2250476

Section 4.55(1A) Modification Application – SSD-67175465 177 Walker Street, North Sydney

Figure 6 Proposed location of the stormwater pits

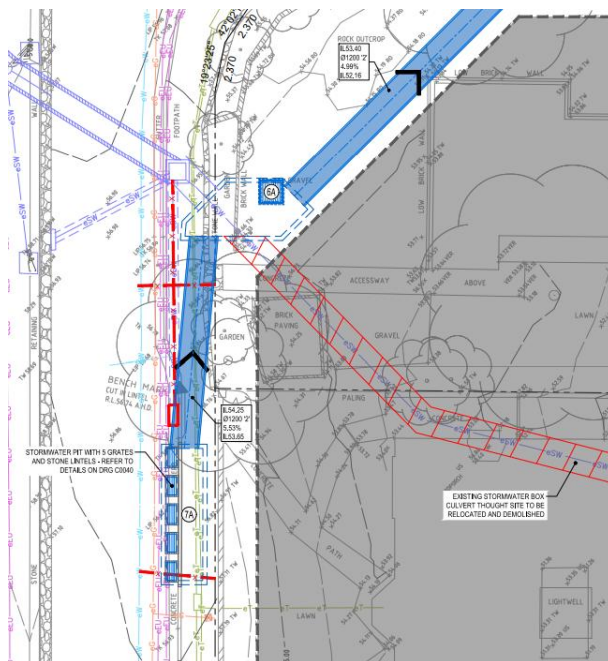
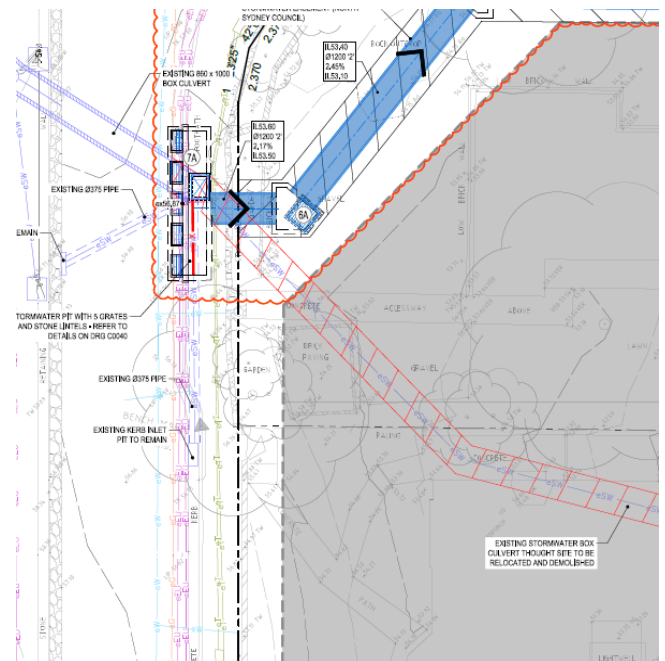
There are amendments proposed to the stormwater pit (7A) along Walker Street to support the stormwater diversion realignment. The stormwater pit is proposed to be relocated further north towards Hampden Street and will be adjacent the existing stormwater pipe under Walker Street. Stormwater pit (6A) is also proposed to be revised as a result of the amendments to the 7A stormwater pit. Stormwater pit 6A has been adjusted to suit the updated pit and pipe arrangements. This amendment is as a result of further design development and to ensure the continuity of the stormwater system and appropriate pipe alignments are retained.
